CALIFORNIA HIGH SPEED RAIL EARLY TRAIN OPERATOR

Review of the 2018 Capital Costs Estimates Associated with the San Francisco – Bakersfield Section (Valley To Valley Concept)

May 1st, 2019

Figure 6-2 - Cost comparison - foundation costs of CHSRA viaducts and bridges versus DB viaducts and bridges

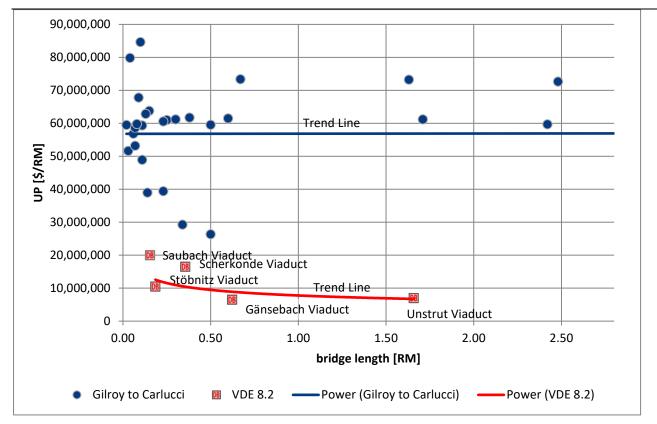
The cost of the foundations for CHSRA viaducts and bridges, in comparison to the DB viaducts, vary greatly, because of the increased depth of the drilled shafts for the pile foundations.

Figure 6-3 - Cost comparison - substructure costs per road mile (piers, abutments)

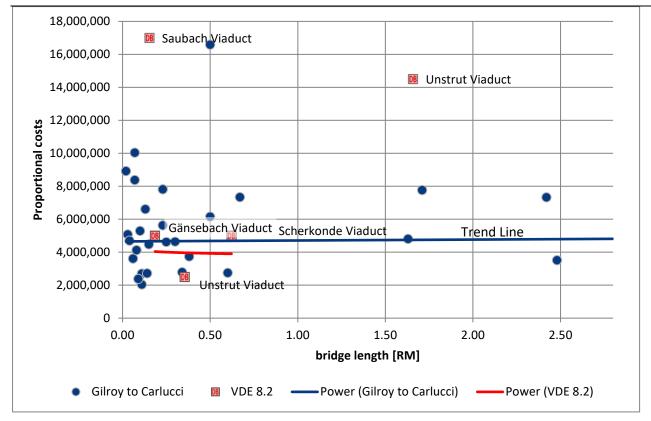
For substructure (Figure 6-3), the costs for the DB reference projects, Saubach viaduct and Unstrut viaduct, are much higher than the average proportional costs. The Saubach viaduct is located in a deep valley, which requires the construction of high piers (up to 120 ft) and one superstructure per track. Consequently, the number of piers is double compared to the other reference projects. The Unstrut viaduct is a flood bridge with unique topography and ground conditions. It is located in a potential flood zone with special environmental impact requirements. Complex construction methodologies were required for construction, which led to increased costs for building the substructure.

Figure 7-1 - HST standard two-track aerial viaduct - typical section with substructure in high seismic zones

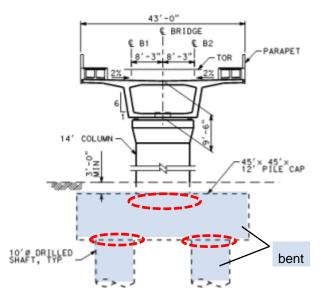
The significant costs deviations are caused by the necessity to design earthquake-resistant structures. In case of earthquakes, pile caps and the underground piles encounter high internal forces caused by ground shaking. Therefore, these structural parts of the viaducts must be designed more robustly to withstand larger movements. Subsequently, they require more materials (e.g. concrete and rebar) in comparison to the DB reference projects. Figure 7-1 highlights the critical structural parts of the viaduct.

2. In high seismic zones, in which CHSRA viaducts and bridges are located, bent construction is the standard solution for foundations. In zones with lower seismicity, mono-piles are preferred. Pile depth and diameter are much larger than those used on DB's reference projects. In

addition, special earthquake-related design details are required, e.g. isolation casings and bents for reducing shear forces.

Figure 7-2 – High-speed rail standard aerial viaduct longitudinal section showing typical situation of isolation casings and bents

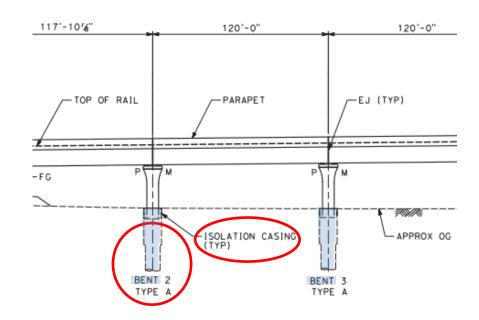
Design details for earthquake resistant structures, as shown in Figure 7-2, are necessary in every bridge axis at CHSRA elevated structures. In contrast, this is not required for DB structures.

Figure 7-4 – Ratio of bridge length (RM) to share of foundations cost

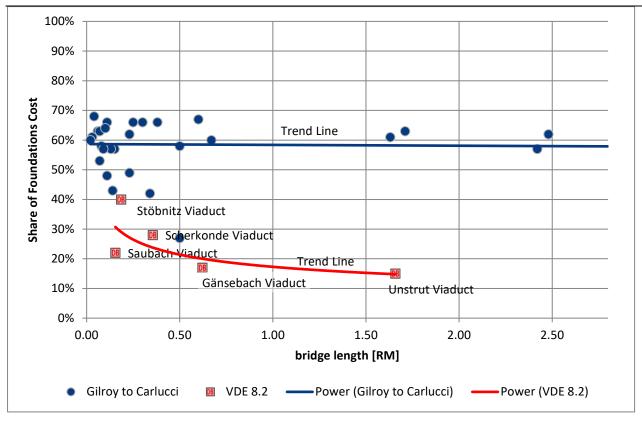
A detailed analysis of the total costs for elevated structures in the Gilroy to Carlucci Road section shows that foundations make up a large share of the structure cost compared to ETO reference projects.
